Access Compliance Report Public Rights-of-Way (Curb Ramps)

Main Street: VAN_BUREN_ST **Cross Street: ELMORE WAY** Location: SW

ADA ID: RPRK220202151439 Ramp Type: Type 4 - Parallel **Initial Pass/Fail: Pass Overall Compliance: No Severity Score:**

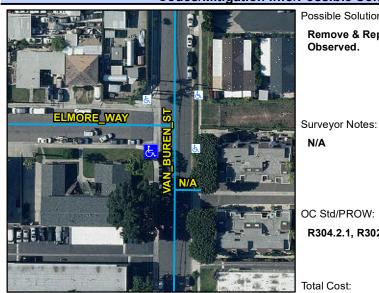
Possible Solutions: Remove & Replace Landing. Gutter Ponding

R304.2.1, R302.7, STD 1115
